Access Compliance Report

Public Rights-of-Way

(Curb Ramps)

Intersection ID: 15321	Main Street: CRESTRIDGE_DR	Cross Street: BRIANNA_WY	Location:	N
ADA ID: 65BDBEBB6EC4	Ramp Type: Perpendicular Diagonal	Initial Pass/Fail: Fail	Overall Compliance: No	Severity Score: 31.25

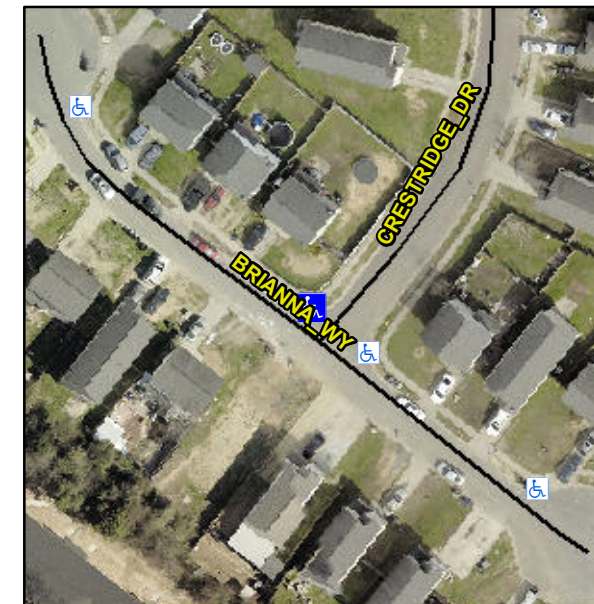
R304.5.1, R304.2.2, R304.5.3

Compliance	Description	Data	Compliance	Description	Data
N/A	Ramp Length (in)	46.0	No	Ramp Slope (%)	8.7
No	Ramp Width (in)	35.0	No	Ramp XSlope (%)	3.0
N/A	Flare Type LT	N/A	N/A	Flare Type RT	N/A
N/A	Flare Slope LT (%)	N/A	N/A	Flare Slope RT (%)	N/A
N/A	Flare Traversable LT?	N/A	N/A	Flare Traversable RT?	N/A
N/A	Landing Length (in)	N/A	N/A	DWS Provided?	N/A
N/A	Landing Width (in)	N/A	N/A	DWS Contrast?	N/A
N/A	Landing Slope (%)	N/A	N/A	DWS Length (in)	N/A
N/A	Landing X Slope (%)	N/A	N/A	DWS Full Width?	N/A
N/A	Landing Curb? (Y/N)	N/A	N/A	DWS Offset (in)	N/A
N/A	Shared Landing?	N/A			
N/A	Gutter Ponding?	N/A	N/A	Gutter Slope (%)	N/A
N/A	Gutter Lip Ht (in)	N/A	N/A	Gutter X Slope (%)	N/A
N/A	Painted X Walk1?	No	N/A	Painted X Walk2?	No
	X Walk 1 Direction	To SW		X Walk 2 Direction	To SE
N/A	X Walk 1 Width (in)	N/A	N/A	X Walk 2 Width (in)	N/A
	X Walk 1 Slope (%)	2.6		X Walk 2 Slope (%)	0.1
	X Walk 1 X Slope (%)	0.1		X Walk 2 X Slope (%)	3.1

Remove & Replace Curb Ramp With Two New Directional Ramps or Equivalent.
